# UNITED STATES PATENT AND TRADEMARK OFFICE

10/719,438

<b>Office Action Summary</b>	Application No. 10/719,438	Applicant(s) CRAZE, JEAN PAUL	
	Examiner Charles N. Greenhut	Art Unit 3652

Fig. 13

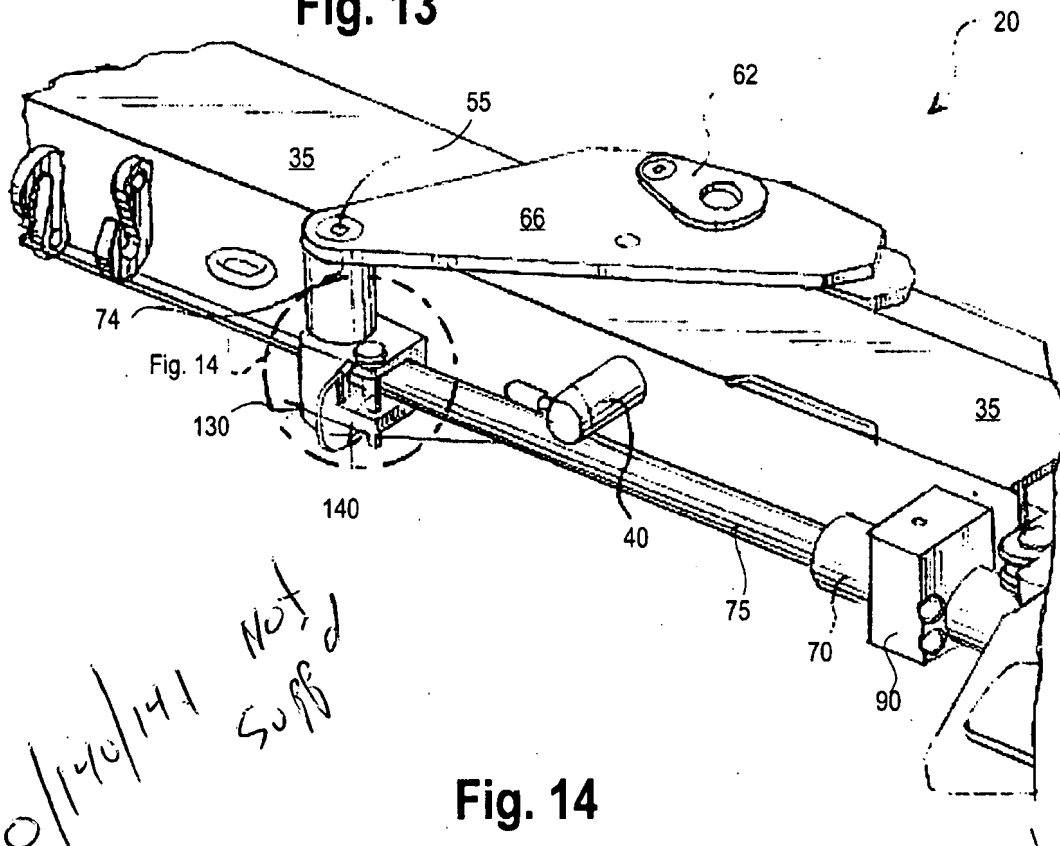
2. Figures 13-16 are objected to as containing new matter as discussed below. Additionally,
  - 2.1. reference numeral 60 has previously been used to reference the plates on adjacent sides of the receiver while “66” is used to reference what appears to be the same feature in figures 13-16. Like features should have the same reference numeral. The record should be clarified with respect to this matter in response to this action.

- 2.2. reference numeral 55, has previously been used to reference the pivot pin, whereas reference numeral 57 has previously been used to reference the cylinder rod connecting pin. In figures 13-16 and the corresponding description, however, “55” appears to be used to denote the cylinder connecting pin. The same reference numeral may not be used to denote different features. The record should be clarified with respect to this matter in response to this action.

1.1. The figures 13-16 showing elements 130, 140 and 141 and corresponding description are not supported by the original disclosure.

2. Applicant argues, by remarks and declaration, that figures 13-16 do not contain new matter because a person of ordinary skill in the art would have understood that the design shown in figures 13-16 had been disclosed in the specification as originally filed. This argument is not persuasive. Firstly, Applicant has supplemented the figures by an amendment to the specification describing the cylinder rod coupling configuration of figures 13-16 as an alternative design. This is evidence that the coupling method shown in figures 13-16 was not contemplated by the original disclosure. Secondly elements 130, 140, and 141 and their corresponding subcomponents are not described anywhere in the specification as originally filed. The paragraph Applicant points to to provide support for this amendment merely states, in relevant part, that, "The cylinder rod connection point may also need to be connected or disconnected as well. For this purpose, the distal ends of each cylinder rod may include an aperture for use in coupling each cylinder rod to a receiver. Alternatively, each cylinder rod may consist of two component rods that are connected to each other, e.g., one may be slidable within the other and they may be attached using a removable locking pin allowing rapid field disassembly." Neither of the contemplated embodiments supports the embodiment shown in figures 13-16. The first requires the cylinder rod to have an aperture (e.g., Fig 4 -75a) which the cylinder rod of figure 14 does not. The second requires the cylinder rod (75) to be composed of two component rods, one slidable within the other, which is not shown in any figures. While it is known in the art that the terminal portion of the rod may take either the form shown in the figures 1-12 embodiment or the 13-16 embodiment, the coupling device itself, generally indicated at 130/140/141 and its attachment to the rod end and the receivers

Do Not -CG  
Enter

Applicant is required to cancel the new matter in the reply to this Office Action.

Fig. 14

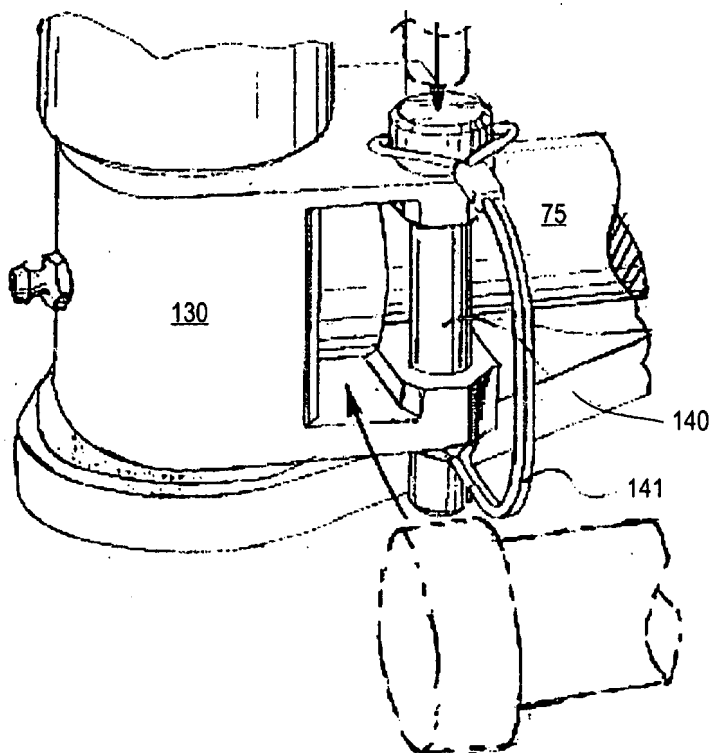
130/140/141 Not  
supp

Do Not  
Enter NEW DRAWINGS  
-CG
